New Albany Architectural Review Board Meeting Agenda
Monday, June 8, 2026, 7:00 p.m.

New Albany Architectural Review Board
Monday, May 11, 2026 Meeting Minutes - DRAFT

**6600 NEW ALBANY-CONDIT ROAD OFFICE
FINAL DEVELOPMENT PLAN**

**Architectural Review Board Staff Report
June 8, 2026 Meeting**

Image: Proposed monument sign.

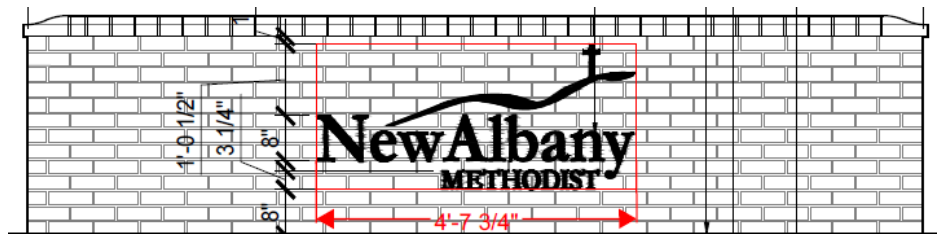
- C.O. 1169.17(c) does not permit monument signs in the Campus sub-district of the Village Center. The applicant is requesting a waiver to allow the monument sign. For other sub-districts and use categories, the city sign code has the following requirements:

Justification: The intent of the zoning regulation to not allow monument signs is to ensure signage within the village center is pedestrian scaled and fits harmoniously with structures and their surroundings. The design intent of the sign in question is not to create a monument sign at this location but strict interpretation of the code results in the sign falling under the definition of a monument sign. Due to this technical definition, the city is requesting a waiver. However, the sign is located on an existing brick retaining wall that delineates the private site from the public right-of-way. The sign meets the goals of the strategic plan because its design is incorporated on a wall that is a cohesive design element that encompasses the entire street frontage's. It is not a typical, free standing monument sign.

- The relief and lighting have not been specified in the plans. Staff recommends a condition of approval that the dual-post sign have a minimum relief of one inch and not be illuminated, subject to staff approval (condition #1).

Approved

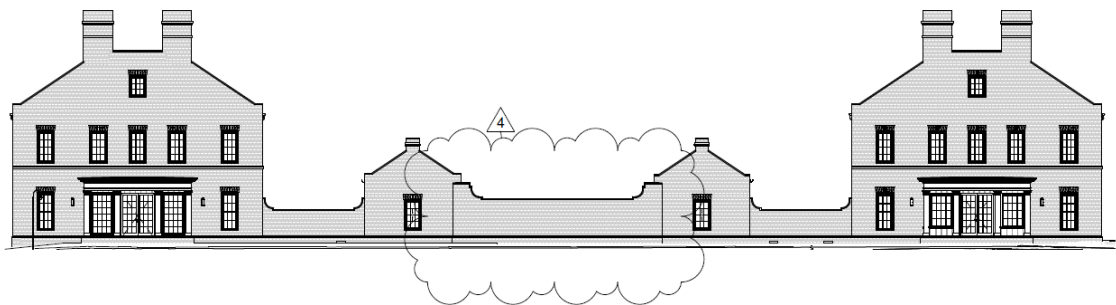
- The applicant proposes redesigning the brick wall along Main Street by eliminating the window well cutout, light fixtures along the brick wall, and altering the cap details.

- The brick wall is now proposed to feature a blank façade with a consistent height along Main Street between the two units. The previous design of the brick retaining wall was approved with a condition that states, “Guardrails at the window wells and iron work on the center Main Street retaining wall shall be subject to staff approval if required.” Since the new design proposal does not include these specific details as part of the condition of approval from ARB-106-2023, the application has come back to ARB for approval of the changes.

- The applicant has proposed to remove light fixtures, a window well cutout, and the proposed metal railing that were part of the previously approved brick wall.

Image: Proposed site layout, showing the buildings, pavement and parking, and general landscaping.

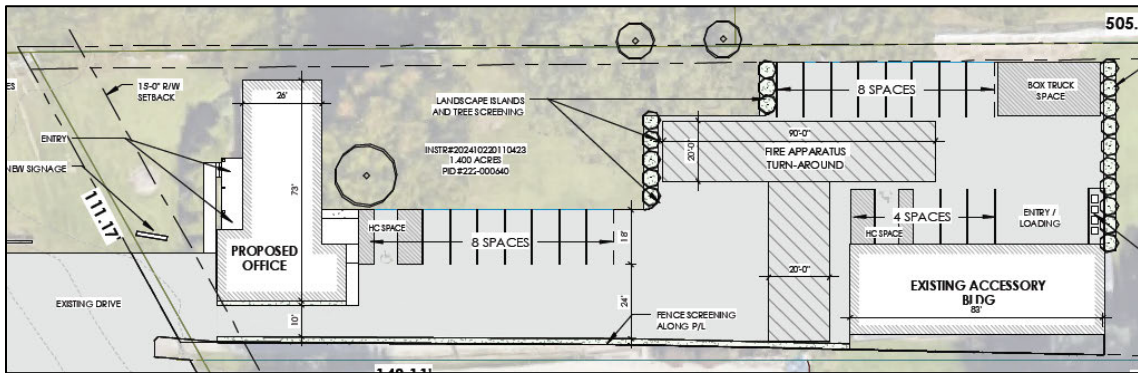
1. **Access:** Vehicular access to the subject parcel is proposed to be provided from New Albany-Condit Road in its existing condition. The application for the rezoning was approved with a condition that the final development plan shall include details to further delineate the route to access the driveway from the driveway on the parcel to the south of and adjacent to this zoning district for review and approval by the Planning Commission. Engineering staff has conducted a preliminary review of the site access and noted that if a typical commercial curb cut were to be installed, the adjacent property would likely need to connect its driveway to the commercial driveway, requiring cross-access and removing direct access to New Albany-Condit Road. As such, the preliminary recommendation of the City Engineer is to allow the driveway to remain as it currently exists. Further comments regarding the proposed entry will be provided following the completion of the Traffic Access Study for evaluation by the Planning Commission.

6. A Traffic Access Study will be completed for Planning Commission review.
7. As required for commercial developments by the Urban Center Code (see UCC evaluation below), staff recommends a condition of approval that a bike rack be installed on the site, subject to staff approval (condition #2).

Image: Axonometric sketch from the City Architect depicting the proposed garage relative to the main entry mass.

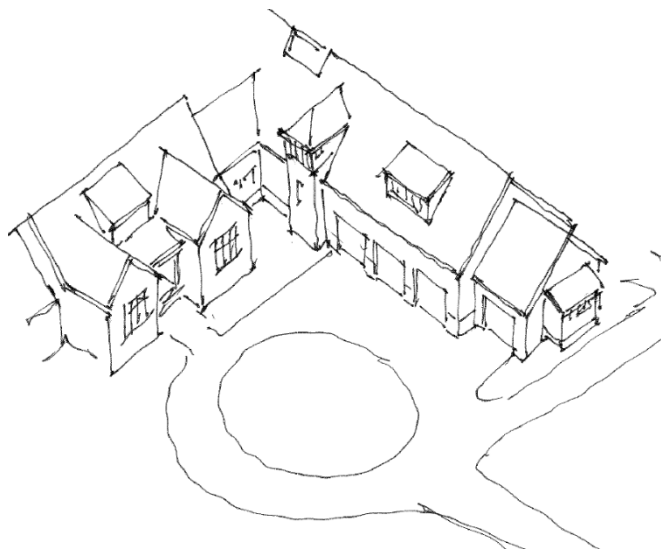
- The applicant proposes a new home with a large garage mass extending approximately 55 feet from the main portion of the home toward the public right-of-way. The garage mass includes four garage doors that face the eastern side yard and are not front facing, though they are in front of the main portion of the house. The garage mass appears to be approximately 30 feet in height and is one of only a few portions of the house with a second-story dwelling area.
- DGR Section 1(I)(E) states that parking areas and garages should be placed in locations to minimize their visual impact through a combination of garage location and landscaping or other screening methods. It further states that garage doors should not be on primary façades

of buildings. Similarly, the Engage New Albany Strategic Plan encourages rear or side-loaded garages, and when a garage faces the street, the front façade of the garage should be set back from the front façade of the house (Engage New Albany, p. 60).

Building B - Proposed

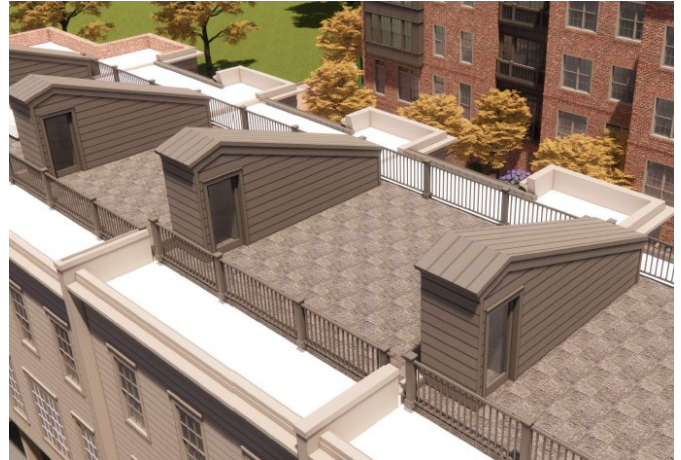
To: Architectural Review Board
From: City Staff
Re: ARB-37-2026 – Upper East Building B Rooftop Garden Access
Date: June 8, 2026

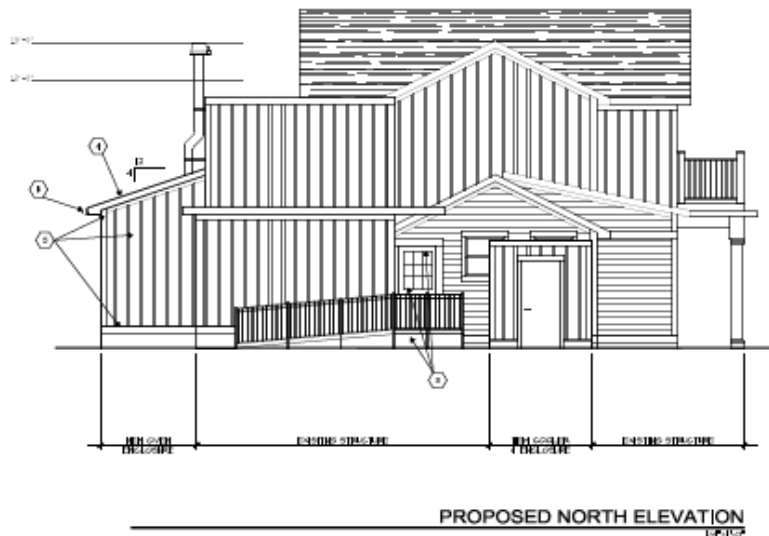
- The applicant proposes the following exterior changes to the building and site:
 - A new pizza oven enclosure.
 - A new detached cooler and enclosure.
- The oven enclosure is proposed to include a ventilated pipe that extends slightly below the highest point of the primary structure's roofline. In addition to the oven enclosure, the applicant proposes relocating the patio ingress/egress slightly to the east to accommodate the addition.

- The cooler enclosure is proposed to be detached and located next to the existing ramp on the north side of the building, and will have the same building materials as the existing structure on site.

- It appears that all of the proposed exterior building modifications appropriately relate to the original ARB approval through the use of the same Hardi board siding material, roof, trim, and details. While the applicant proposes to replace the double French doors on the east elevation, there are still two building entrances along this elevation.
